**ORDNANCE AND EXPLOSIVES
ENGINEERING EVALUATION/
COST ANALYSIS REPORT – RESPONSE TO
COMMENTS**

**SENECA ARMY DEPOT
ROMULUS, SENECA COUNTY, NEW YORK**

**SENECA ARMY DEPOT ACTIVITY
and
U.S. ARMY CORPS OF ENGINEERS
NEW YORK DISTRICT
and
HUNTSVILLE CENTER**

DESIGNED BY JEB	Figure 3.17 EM-61 Data Collected in EOD Area #2		
DRAWN BY JEB	SCALE 1:1200	PROJECT NUMBER 736703-01000	FACE REVISION
CHECKED BY BJM	DATE JAN 2004	FILE EOD2.APR	
SUBMITTED BY SAS	Figure 3.17

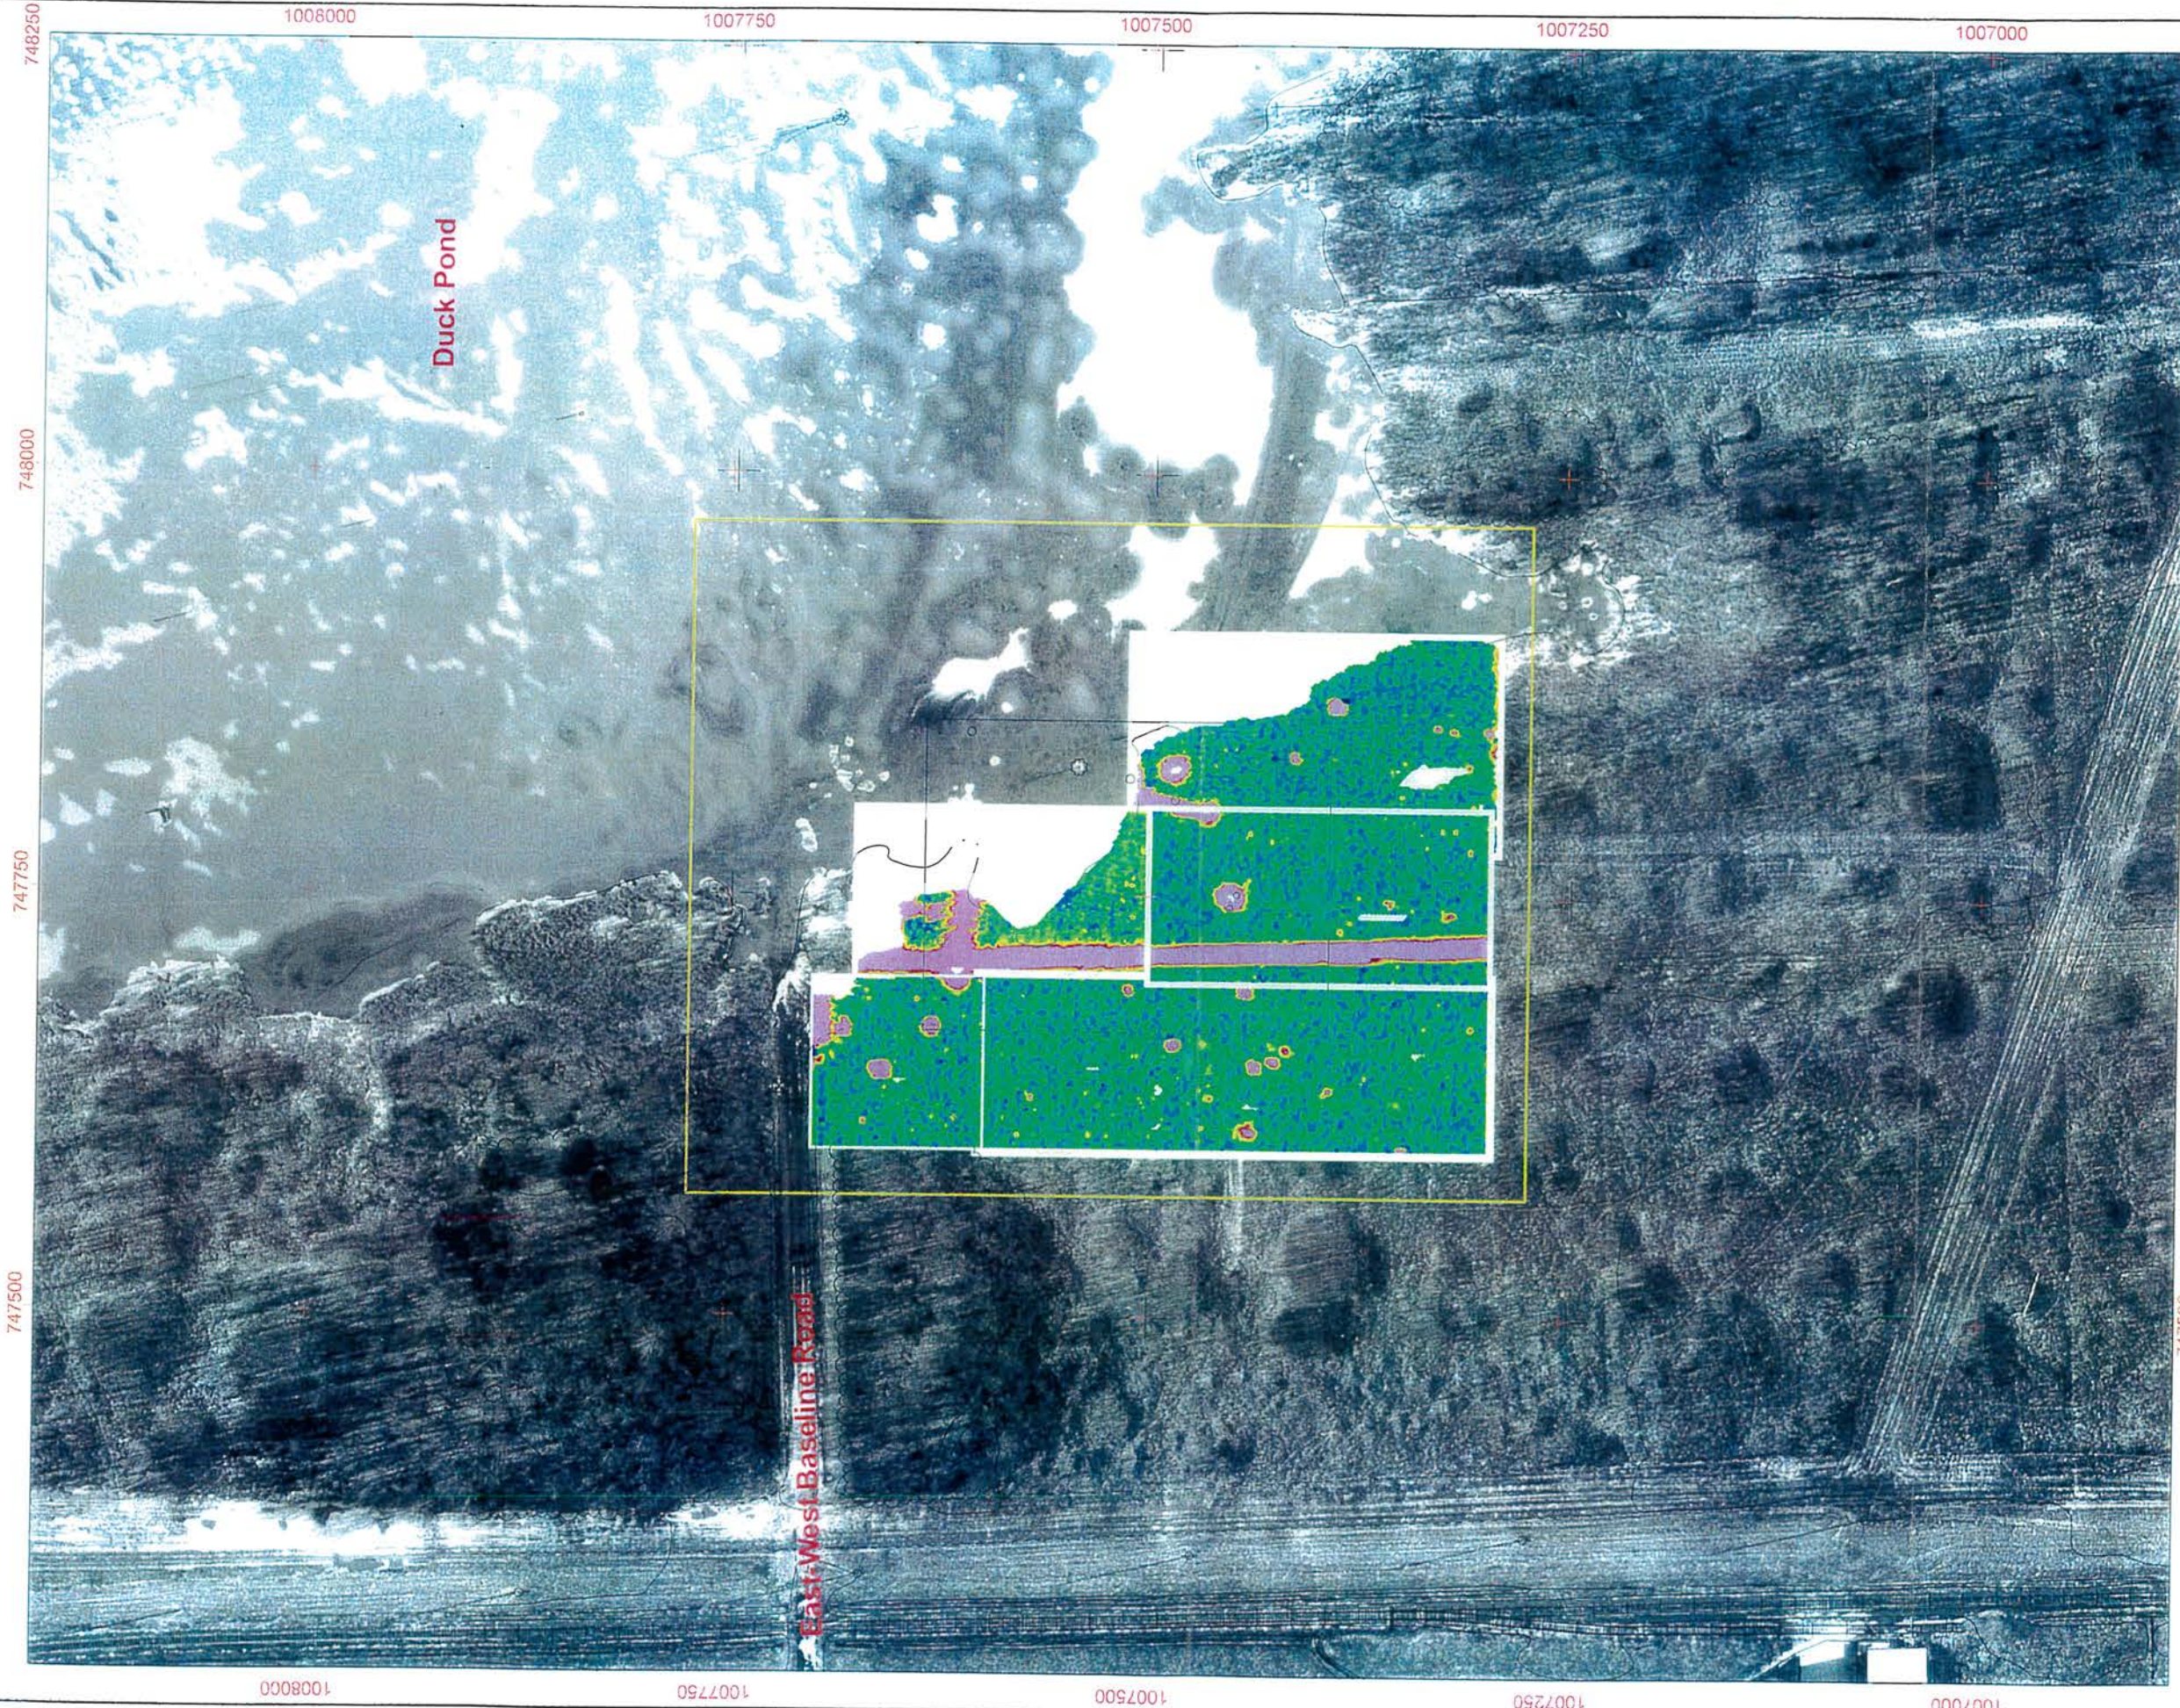
17. This figure provides the area investigated in EOD Area #2. Two linear anomalies are present on this figure. The nature of these anomalies should be explained in the text.

Response to EPA: The anomalies have been explained in Section 3.8.7.1.

DESIGNED BY JEB	Figure 3.29 EM-61 Data Collected in SEAD-57 (Former EOD Range)
DRAWN BY JEB	
CHECKED BY BJM	SCALE 1:3000 PROJECT NUMBER 736703-01000
SUBMITTED BY SAS	DATE JAN 2004 PAGE NUMBER Figure 3.29
	FILE SEAD_57.APR

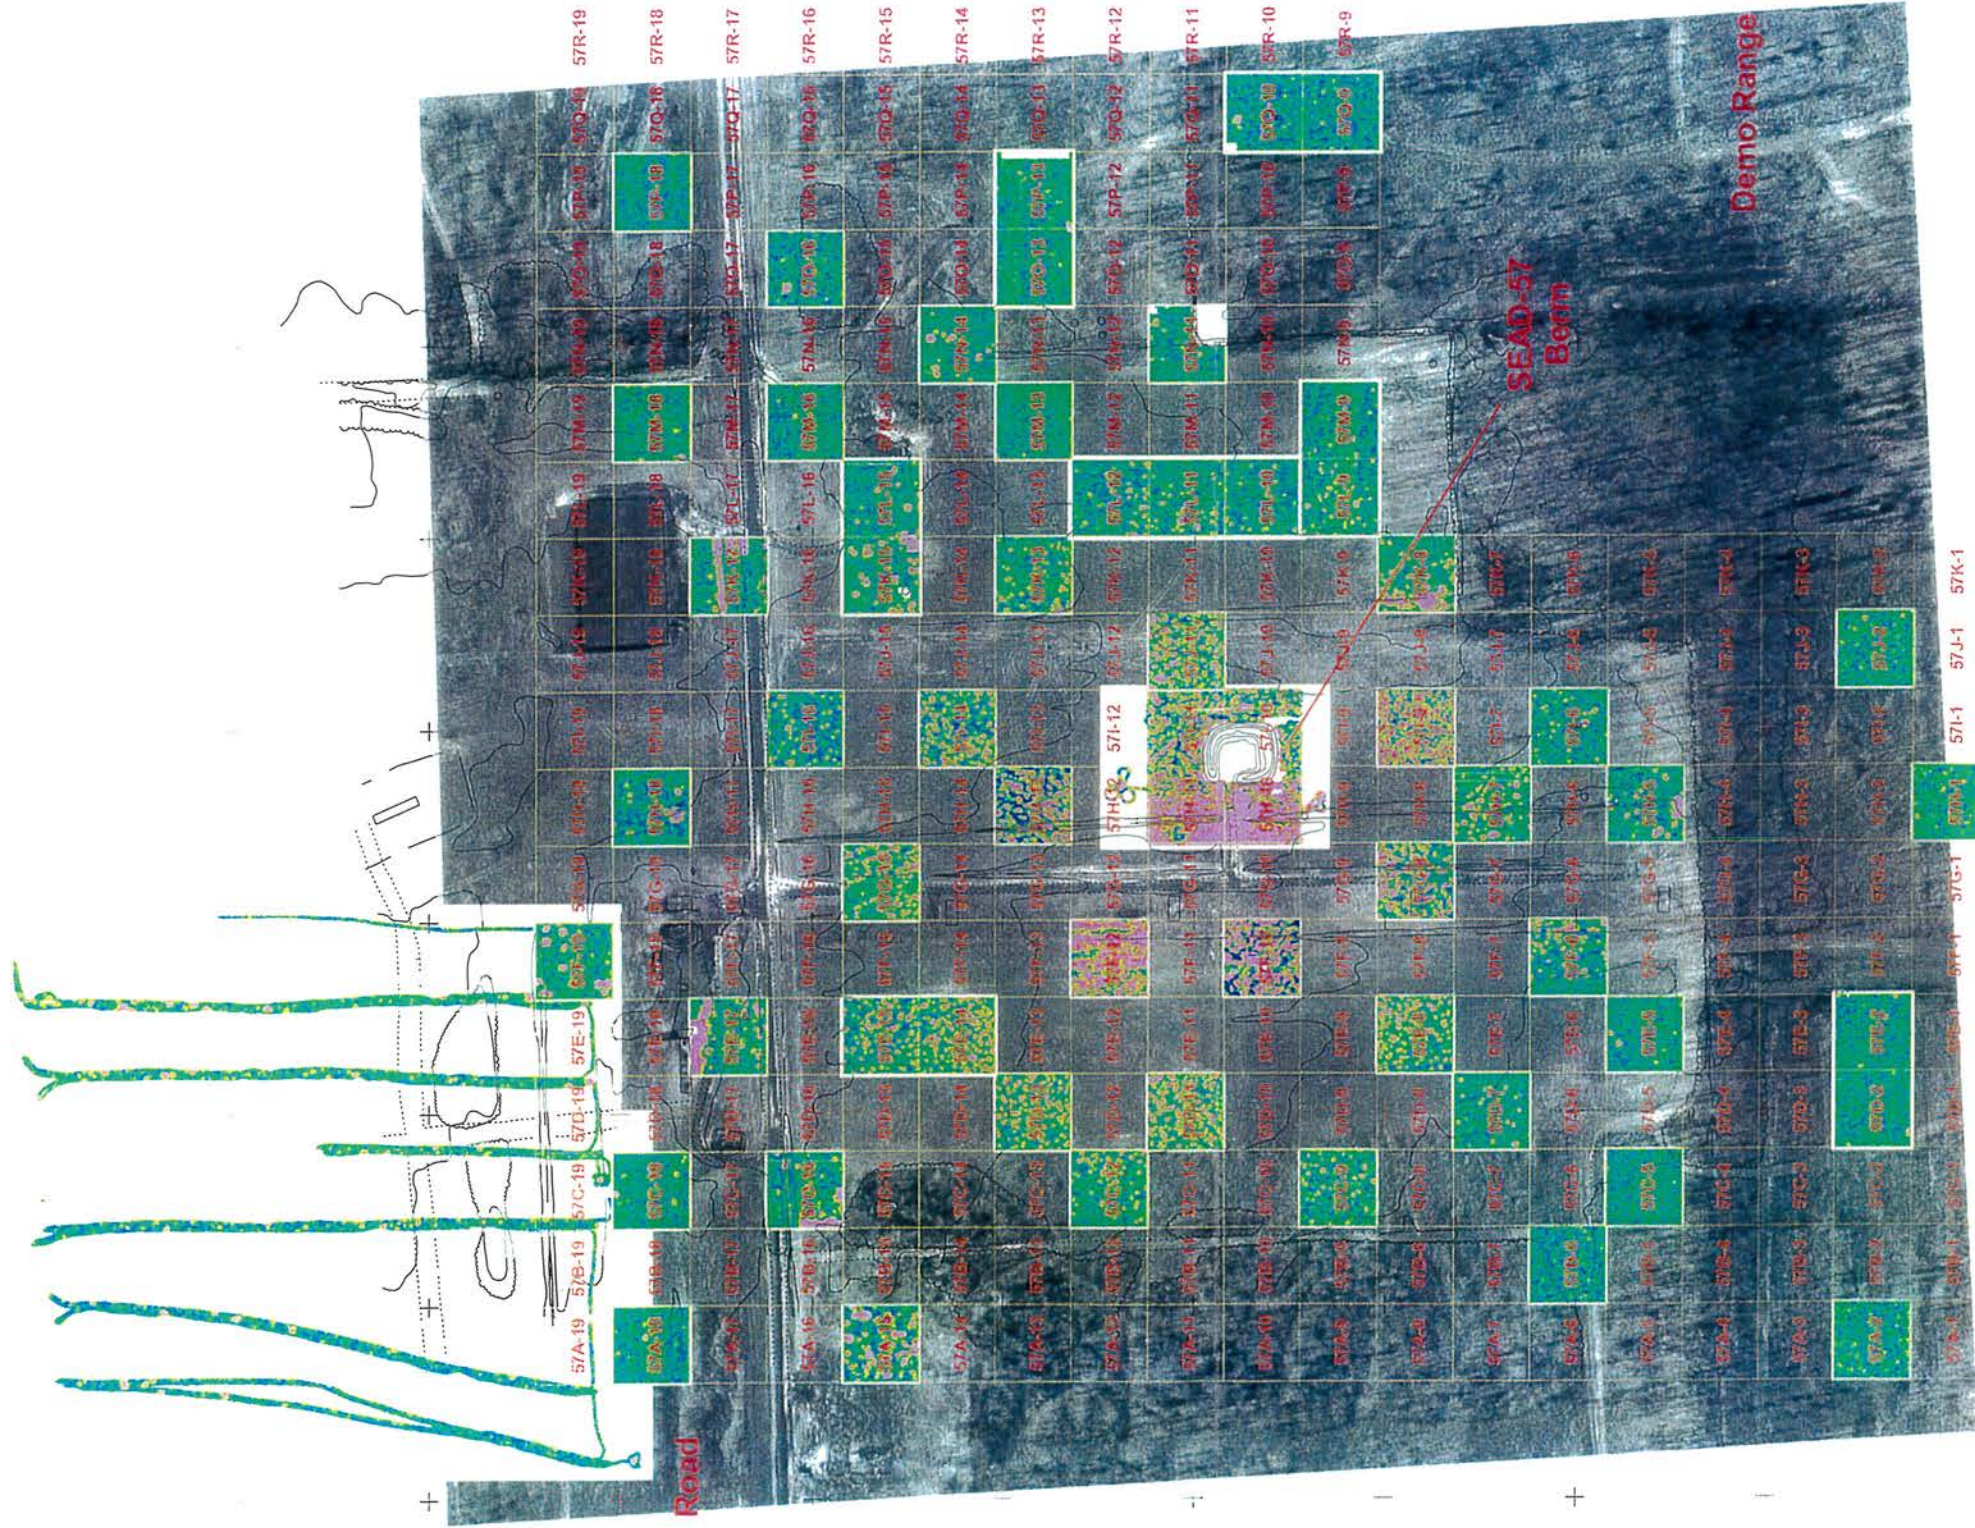
20. **Figure 3.29.** This figure provides the geophysical results for SEAD-57. The meandering path investigation that was conducted for this area appears to extend north of this figure. If the primary objective of this investigation was another area, this area should be labeled on the figure; otherwise, the entire meandering path investigation should be shown on Figures 3.29, 3.30, and 3.31.

Response to EPA: The entire length of the meandering path survey is now shown on Figure 3.29 (Appendix A of this document). No applicable data (OE or UXO locations) is missing from the other two figures, and they have not been changed.

DESIGNED BY: JEB	Figure 9.3 Proposed Area of Clearance EOD Area #3		
DRAWN BY: JEB			
CHECKED BY: BJM	SCALE: 1:1200	PROJECT NUMBER: 736703-01000	
SUBMITTED BY: SAS	DATE: JAN 2004	PAGE NUMBER:	Figure 9.3
	FILE: EOD3.APR

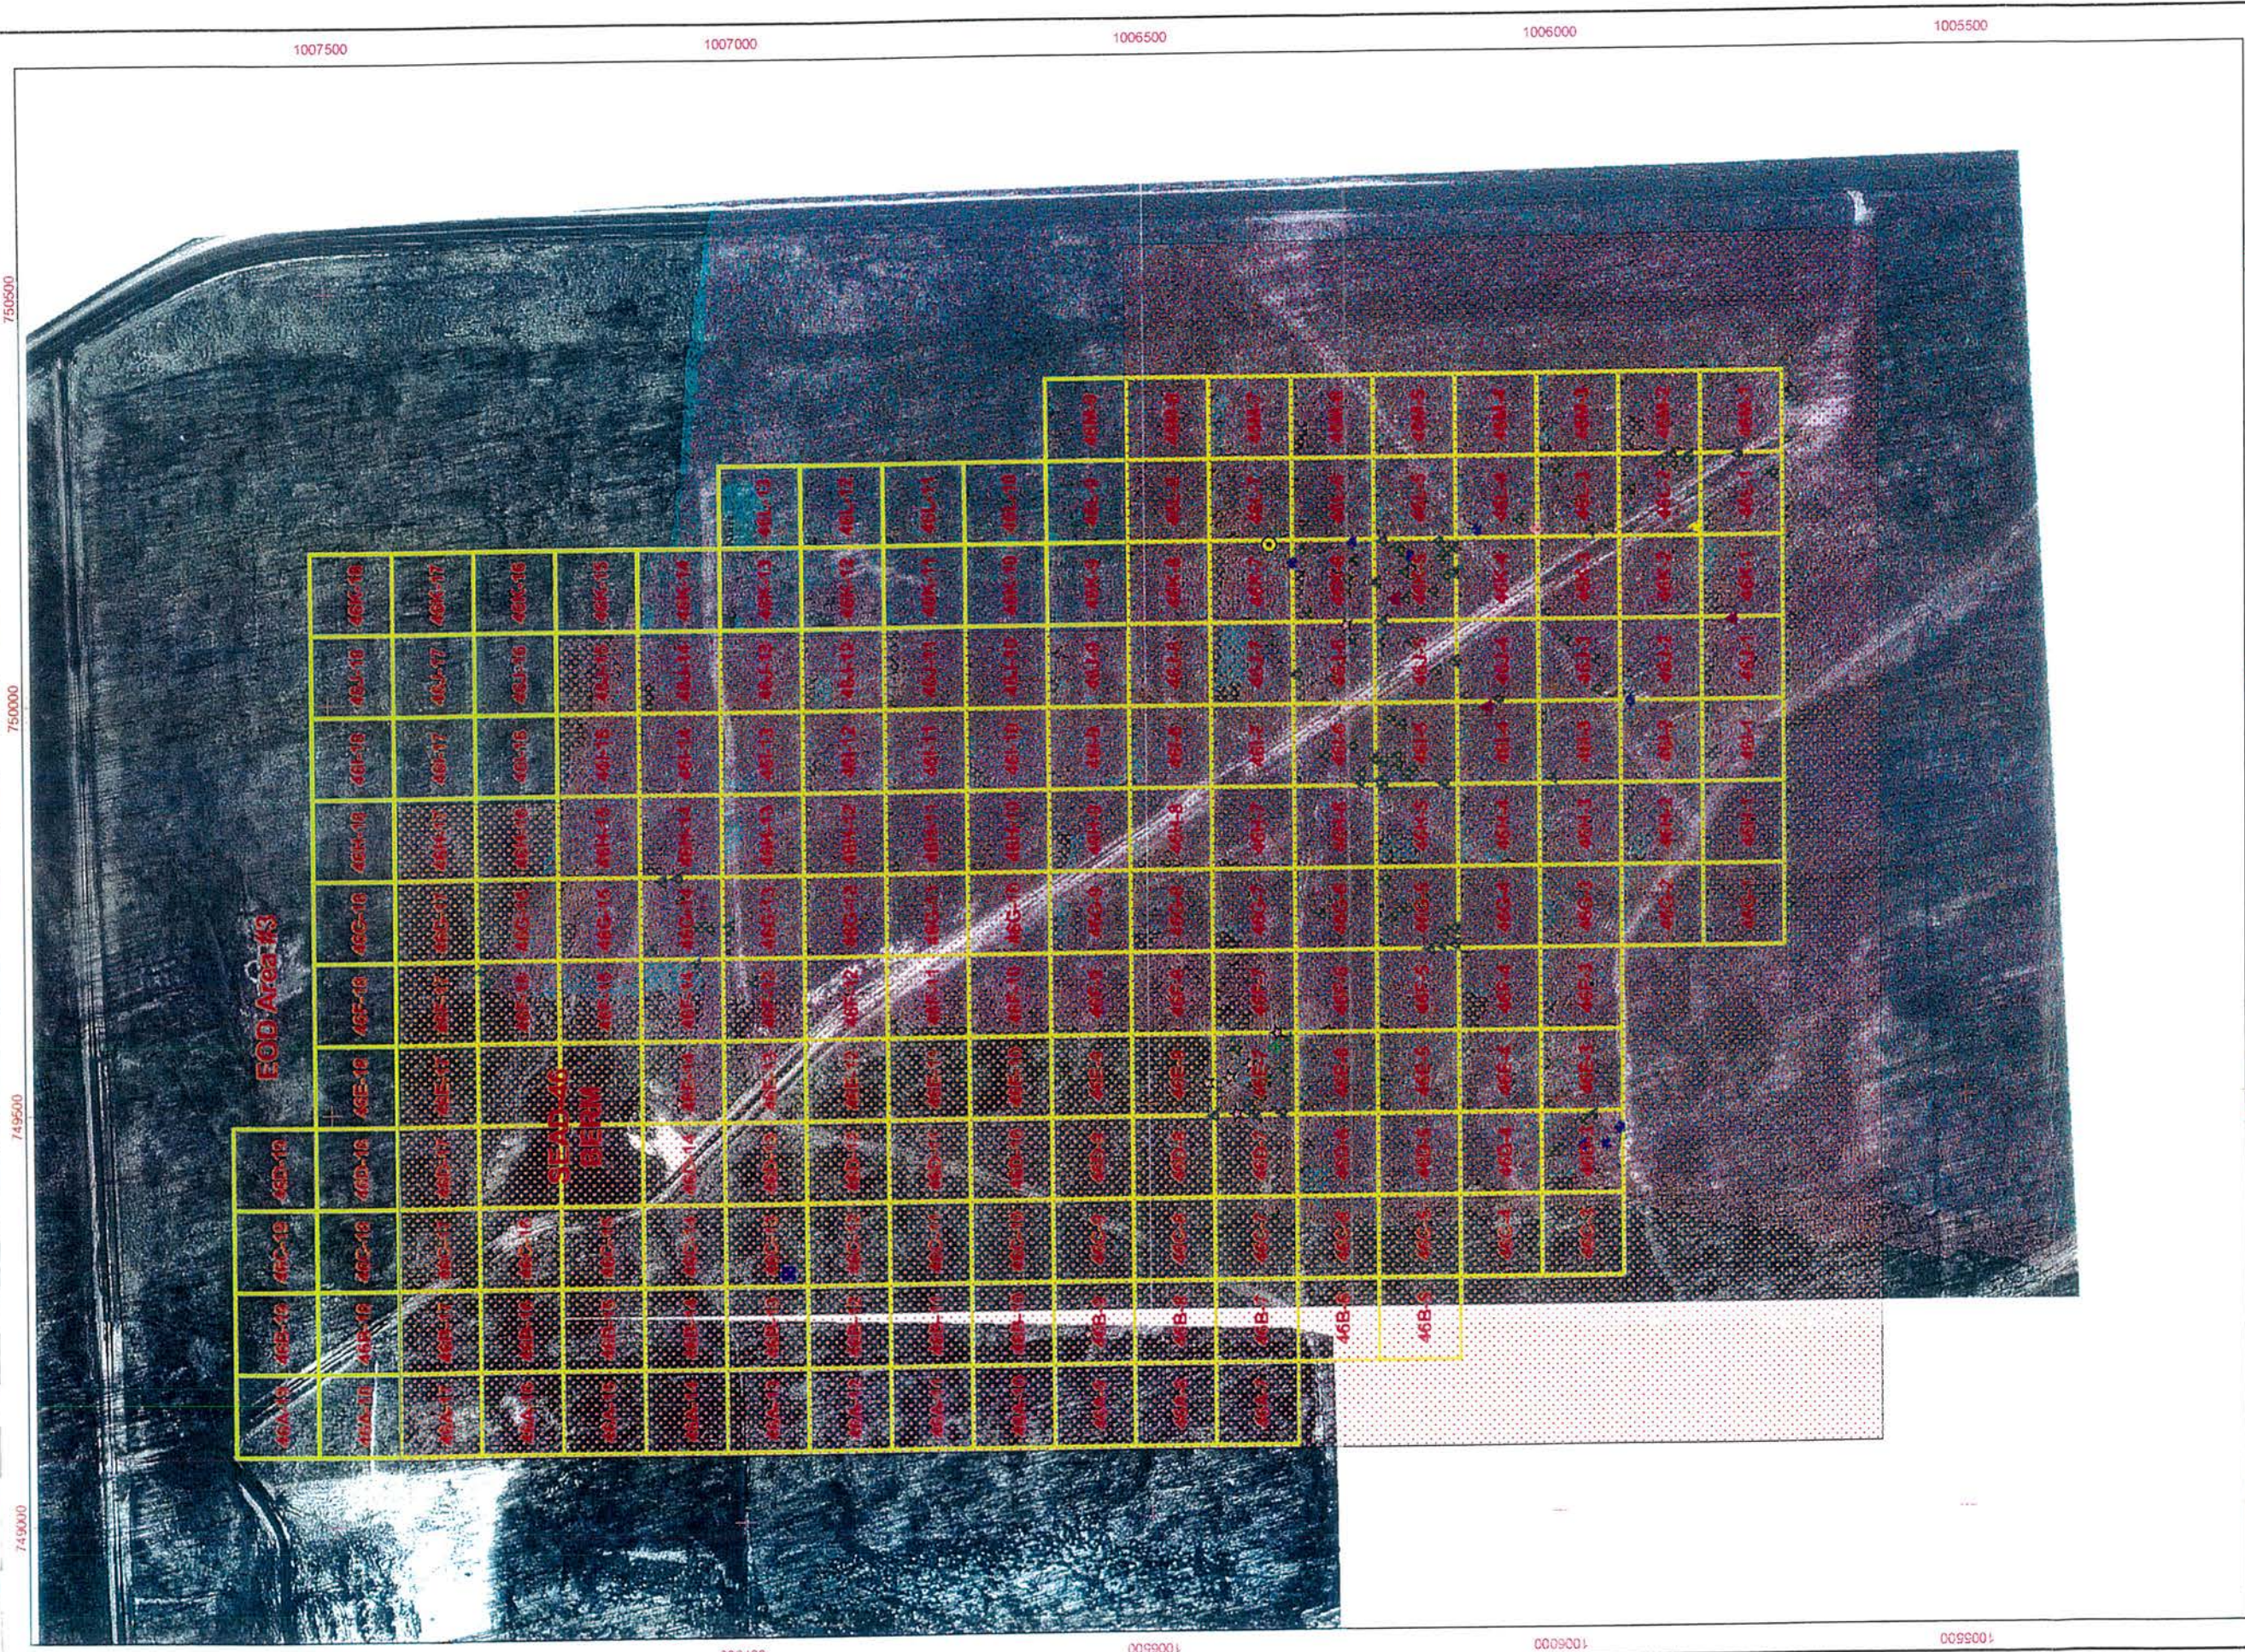
10. **Section 3.8.6, page 3-13.** This section provides information on the investigation conducted at EOD Area #3. Text on page 2-5 indicates that an ordnance disposal pit and ditch were present at the site. The pit is visible on Figure 3.15, and was not geophysically investigated, adding to the uncertainty associated with the response action. Efforts to investigate the pit and ditch at this site should be discussed in the text. In addition, these features should be labeled on Figures 3.15 and 3.16. These areas should be investigated if they can be located.

Section 3.8.6 has been amended to say that the pit was located in the area that could not be surveyed due to thick woods/brush. In part because of this, the proposed response action at EOD #3 is a clearance to depth. Included in the estimated cost for this response action (page G-3) is the heavy brush cutting necessary to investigate the remainder of this AOI. The only more extensive response action would be a scrape and sift. It is highly unlikely that such a process would be necessary in this area judging by the scarcity of OE surrounding the suspected pit.
